Groundwater Application Review Summary Form

Application # G- 19469 re-review

SUBJECT: Scenic Waterway Interference Evaluation

TO: Water Rights Section Date 8/14/2025
 FROM: Groundwater Section Travis Brown
 Reviewer's Name
 SUBJECT: Application G- 19469 re-review Supersedes review of 5/12/2025
 Date of Review(s)

Hydrograph

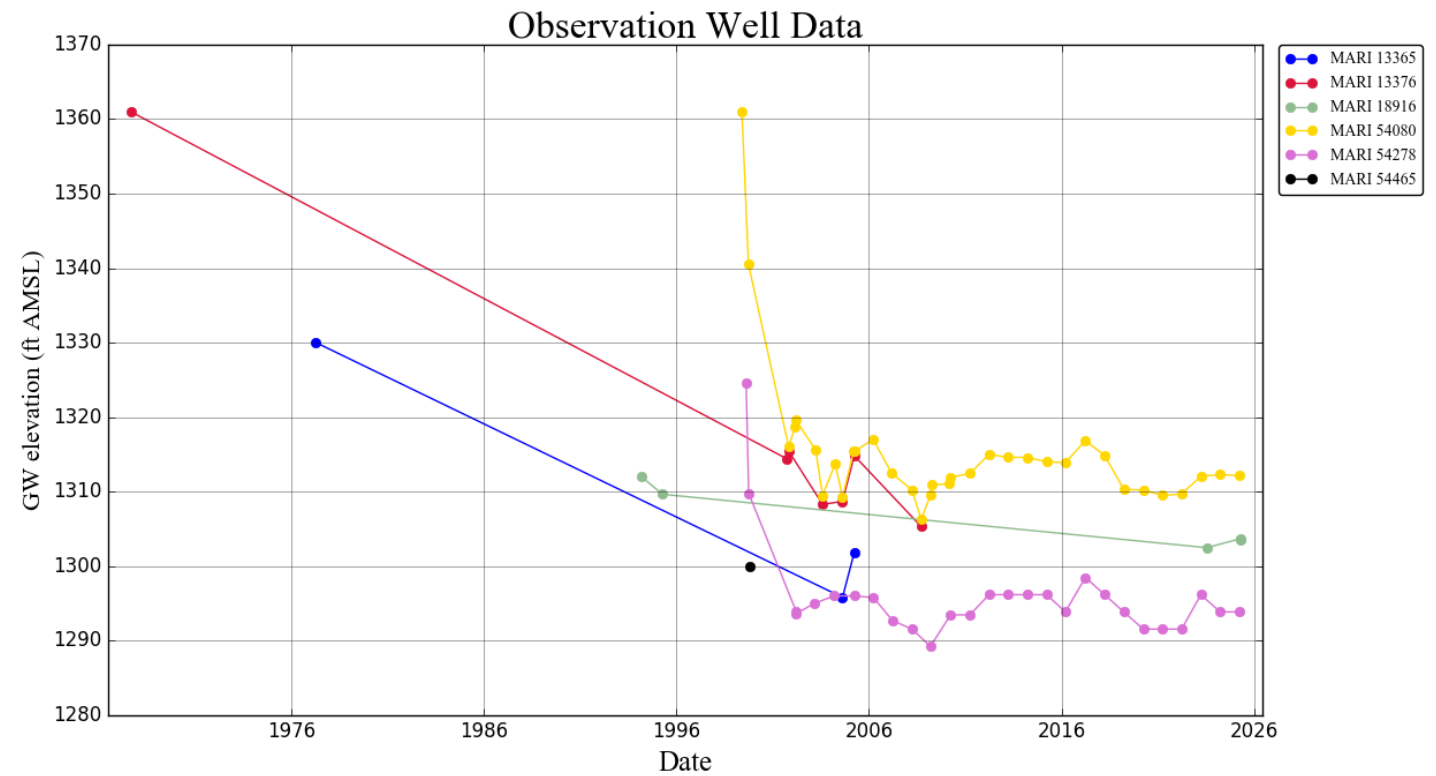
The nearest well with recent water level data is MARI 18916, ~0.5 miles northeast of the proposed POA 1, which has shown an overall decrease in water level of ~8.5 ft since it was drilled in 1994 (see attached Hydrograph). Wells further to the north with current data show relative stability from the early 2000s through 2025 (see attached Hydrograph). However, between 1999 and 2002, MARI 54080 showed an overall decline of ~42.3 ft from the water level reported on its well completion report in 1999. Similarly, between 1999 and 2002, MARI 54278 showed an overall decline of ~31.0 ft from the water level reported on its well completion report in 1999. This pattern of steep initial decline followed by subsequent stabilization may indicate these wells (MARI 54080 and MARI 54278) commingle multiple aquifers. Despite the substantial early declines observed in many Columbia River Basalt wells to the north, most of the wells are not excessively declined or declining, excluding possibly MARI 13376 (for which current data is not available), although MARI 54080 was Declined Excessively per OAR 690-008-0001(5)(d) as recently as 2022. The deeper construction of the proposed POA relative to other basalt wells with water level data to the north, and the significant distance of the POA wells from these other basalt wells, should insulate the proposed POA wells from many of the likely causes of declines in the more distant wells to the north. **The preponderance of the current water level data indicates the proposed aquifer is not over appropriated.**
